Subj: Safety Analysis Report for the CNS 10-160B, C of C 9204, Rev. 15

Revision 17 Changed Pages

SAFETY ANALYSIS REPORT
FOR
CHEM-NUCLEAR SYSTEMS
MODEL CNS 10-160B
TYPE B RADWASTE SHIPPING CASK

REVISION 17

Fig 4.1 - Allowable R-12 Gas/Air Mixture Test Leakage, cm³/sec, versus test temperature, deg.F

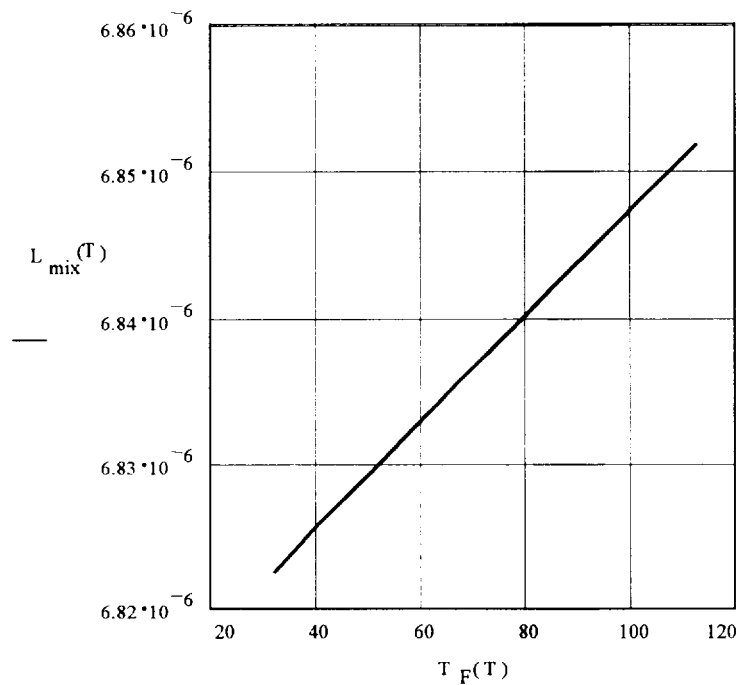
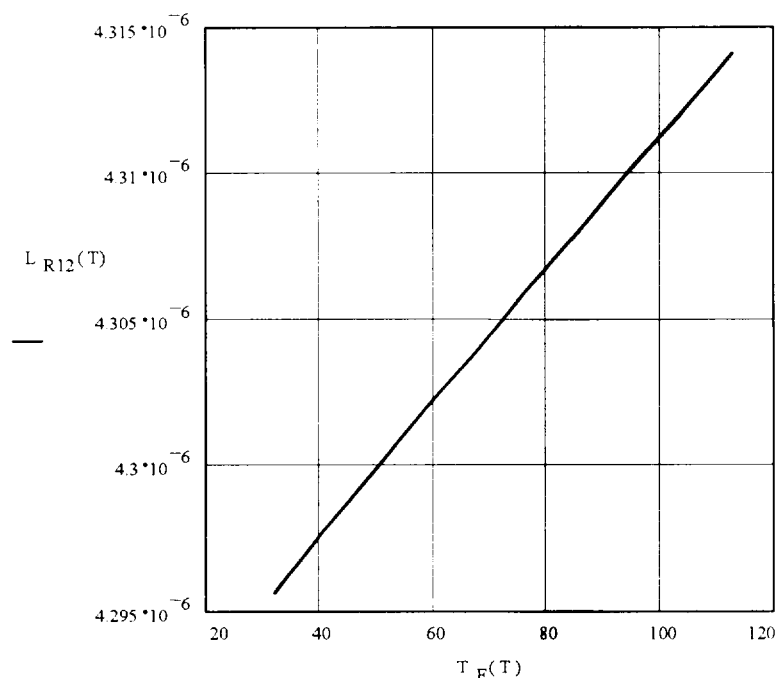
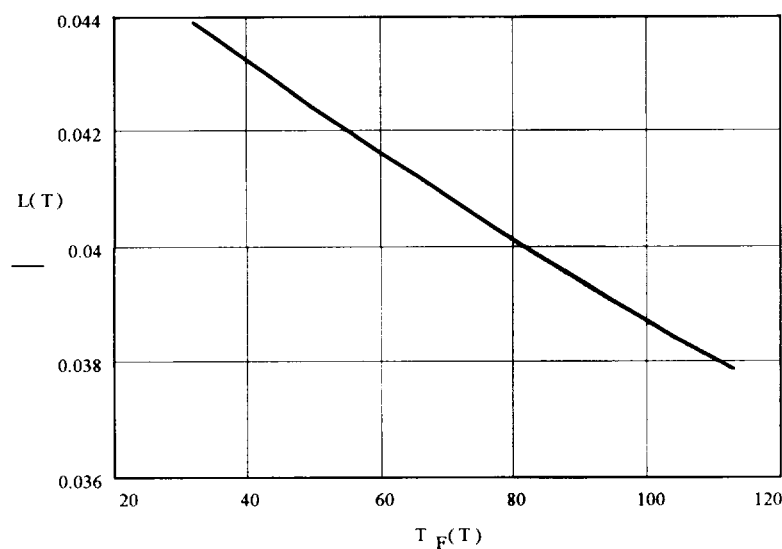
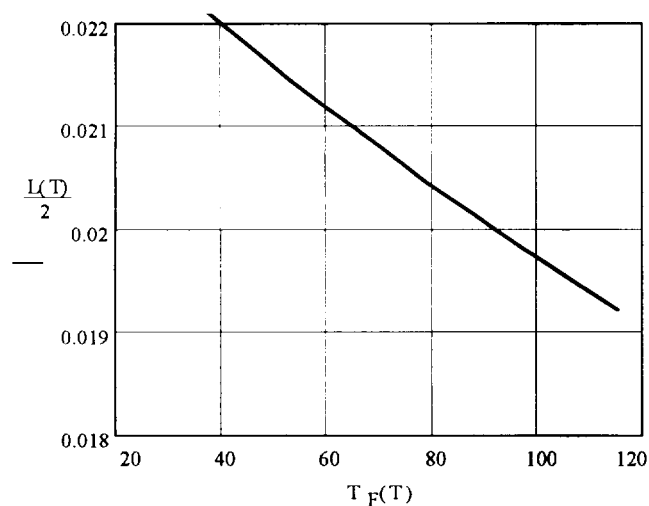
The calculations in this section have been revised for a L_{STD} based on a source term of 3000 A₂.

The values presented in Figure 4.4 should be used to determine the sensitivity to calibrate the leak detec-

Fig. 4.5 - Allowable He/Air Mixture Test Leakage, cm³/sec, versus test temperature, deg.F

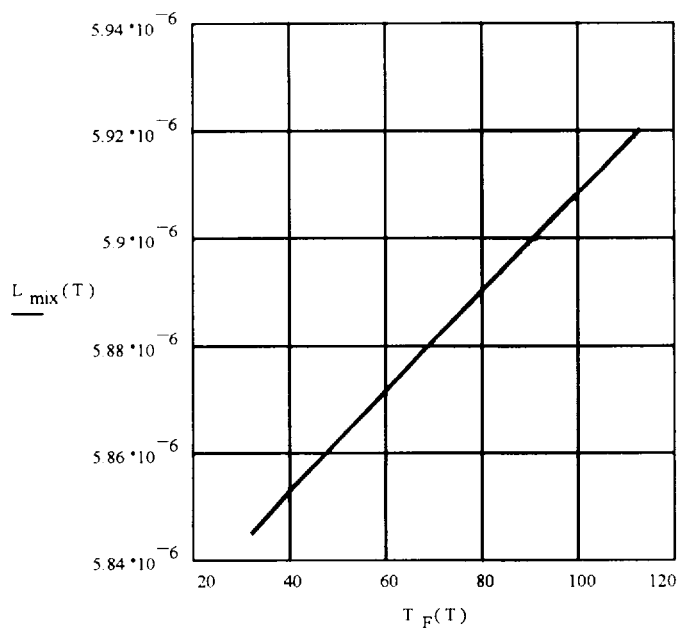
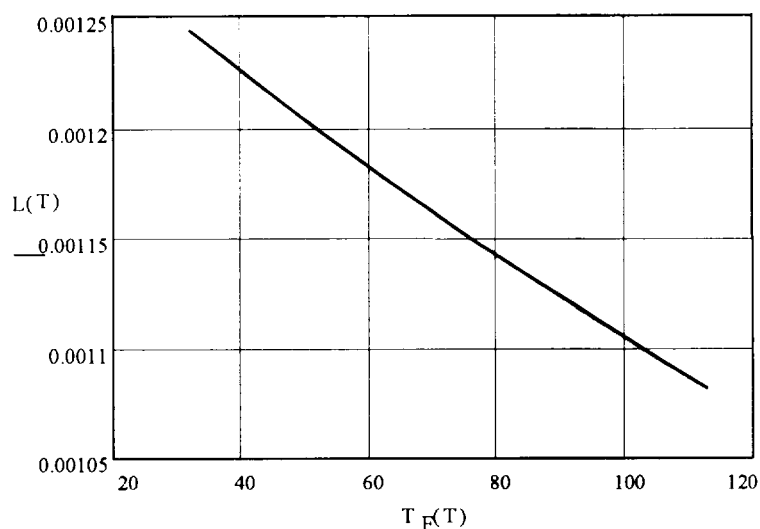
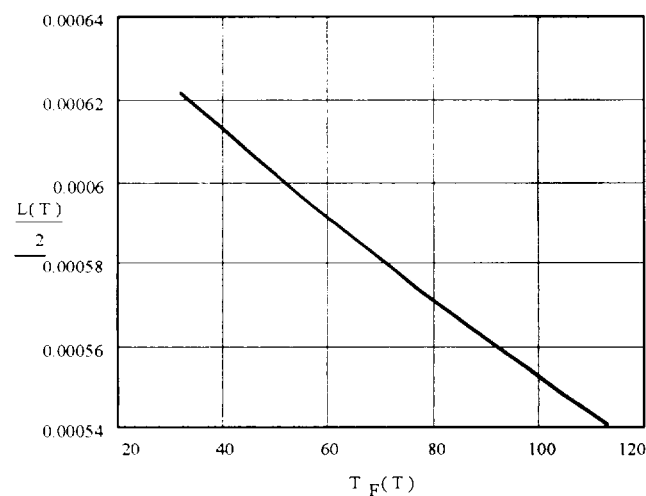
The calculations in this section have been revised for a L_{STD} based on

The values presented in Figure 4.8 should be used to determine the sensitivity to calibrate the leak detector prior to the test.

Fig.4.9 - Allowable R134a/Air Mixture Test Leakage, m³/sec, versus test temperature, deg.F

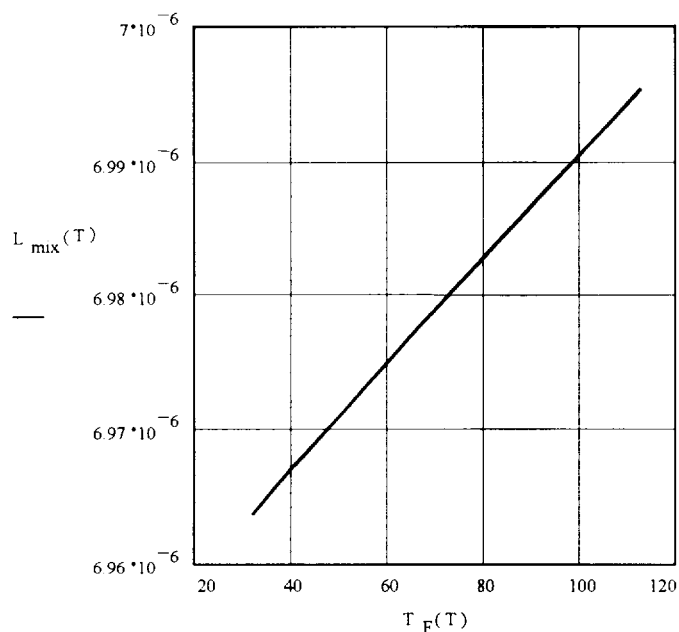
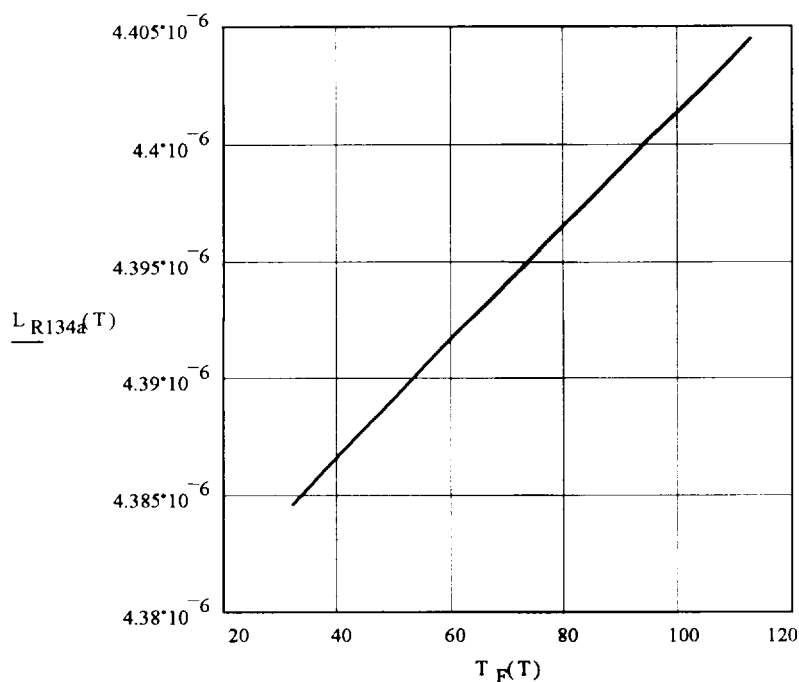
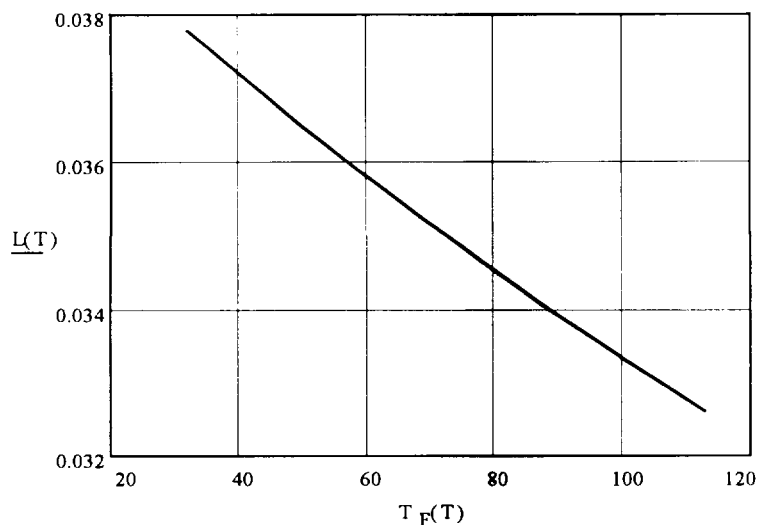
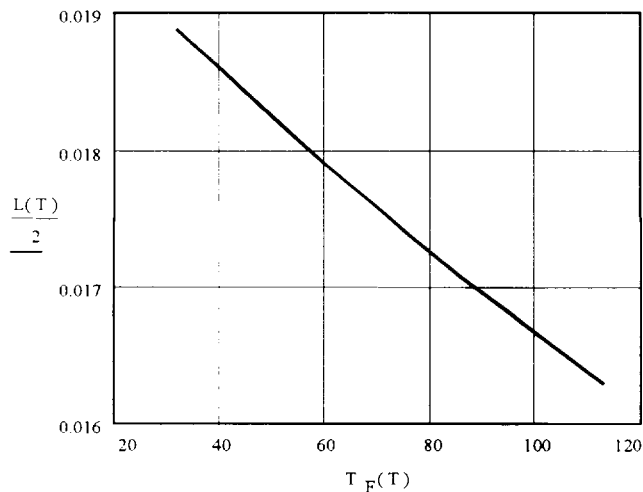
The calculations in this section have been revised for a L_{STD} based on a source term of 3000 A₂.

The values presented in Figure 4.12 should be used to determine the sensitivity to calibrate the leak detector prior to the test.
